Brian Arden Winery – Mitigated Negative Declaration

**Response to Caltrans Comments on the Focused Traffic Impact
 Analysis for the Brian Arden Winery**

RE: **REVIEW OF TRAFFIC IMPACT ANALYSIS FOR THE BRIAN ARDEN WINERY, NOVEMBER 29, 2011**

Re: Brian Arden Winery, Silverado Trail, Calistoga, CA, APN 011-050-030

LEFT TURN LANE WADIANI GRAPH

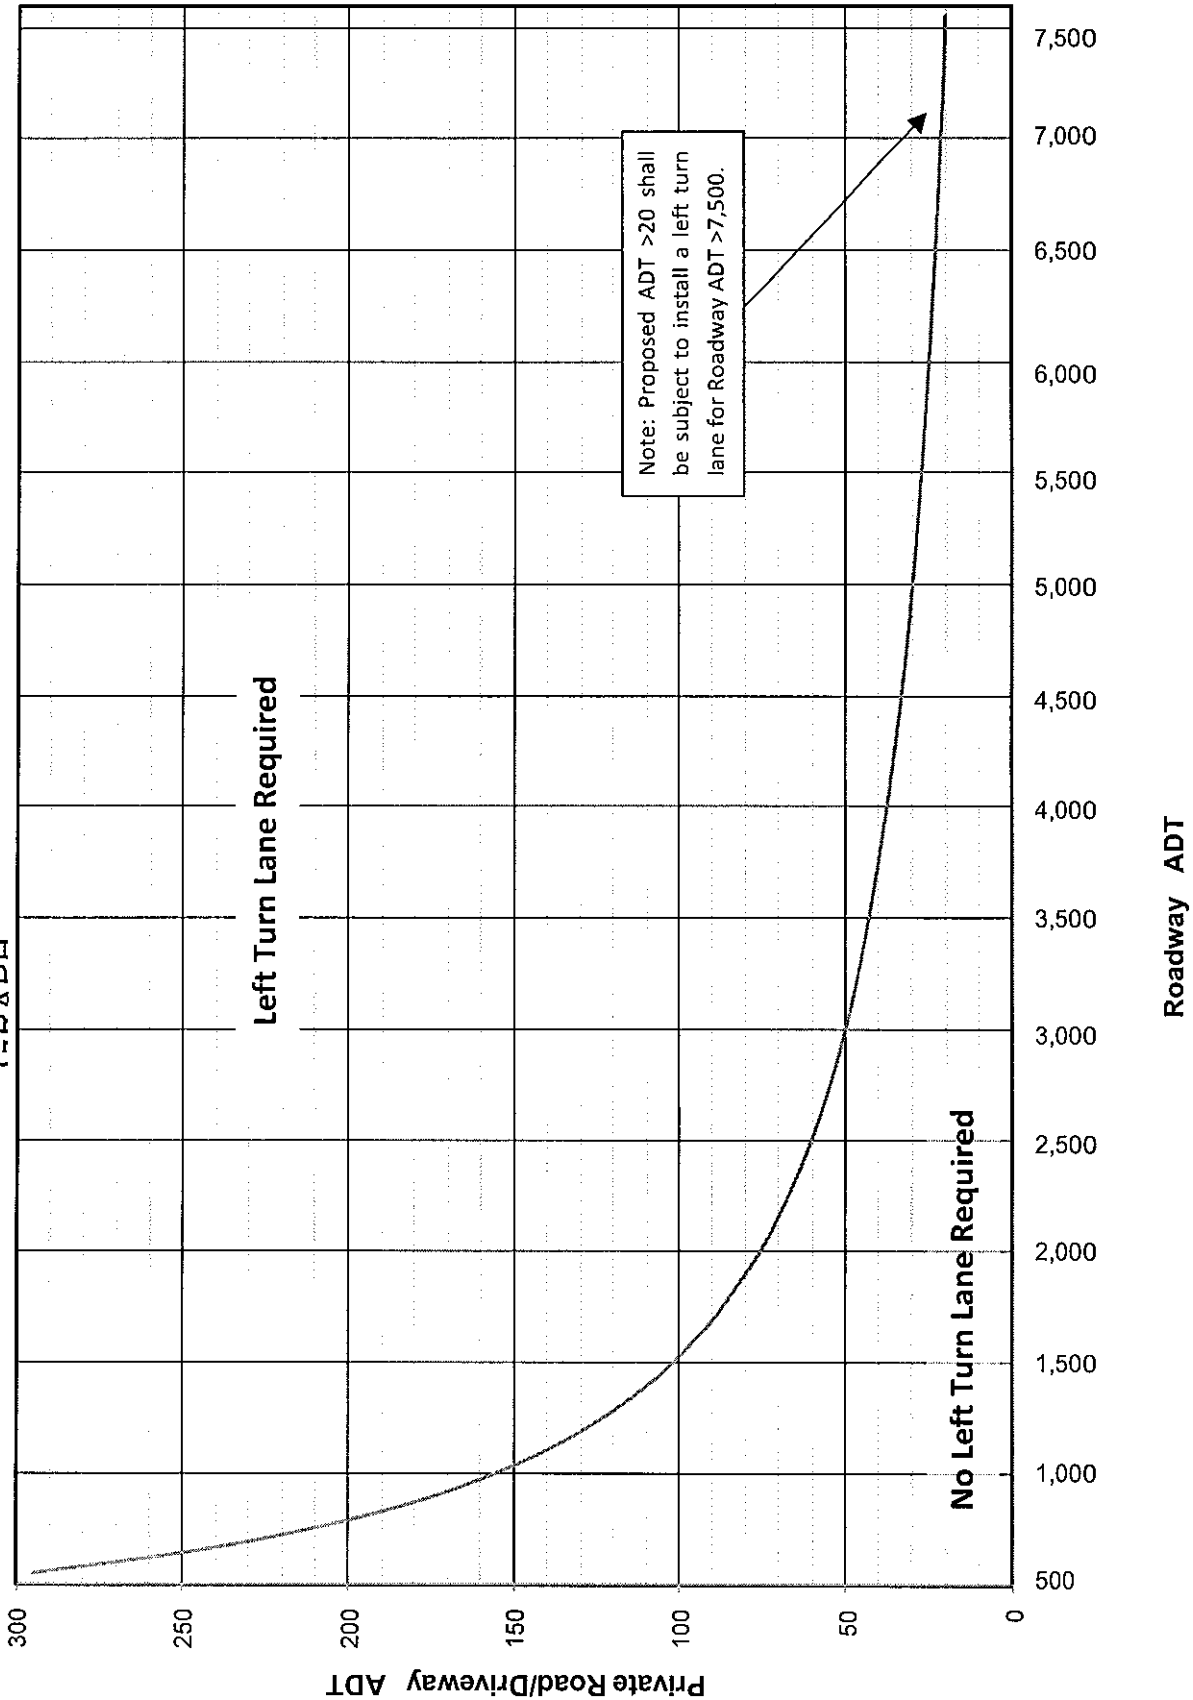
1. **Left Turn Lane Warrant:** the Washington State DOT Left Turn Lane warrant was used in this study rather than the year 2001 update of the referenced NHRCP Report No. 279 (i.e., the update is NCHRP Report # 457, TRB). However, since Silverado Trail is a county road, Napa County standards should govern the requirement for left turn lanes. Use of the Napa County Left Turn Lane warrant has been required by Napa County of the nearby Lava Vine Winery (comment letter re: *Mitigated Negative Declaration for Lava Vine Winery*, to Erik Lundquist, Senior Planner, Calistoga, CA, from Nathan J. Galambos, Principal Engineer, Napa County Public Works, January 11, 2012.) Preliminary application of this warrant indicates that a left turn lane would be warranted. The Napa County Left Turn Lane warrant chart is provided as an attachment to this memo.

1. *Left Turn Lane Warrant: the Washington State DOT Left Turn Lane warrant was used in this study rather than the year 2001 update of the referenced NHRCP Report No. 279 (i.e., the update is NCHRP Report # 457, TRB). However, since Silverado Trail is a county road, Napa County standards should govern the requirement for left turn lanes. Preliminary application of this warrant indicates that a left turn lane would be warranted.*

Response: The references cited in the report are those which contain the formulas and methodologies used for this evaluation, so are the appropriate reference. The proposed access driveway is located along a segment of Silverado Trail that is within Calistoga's City Limits; therefore, application of Napa County's left turn lane warrant is not appropriate for this proposed project.
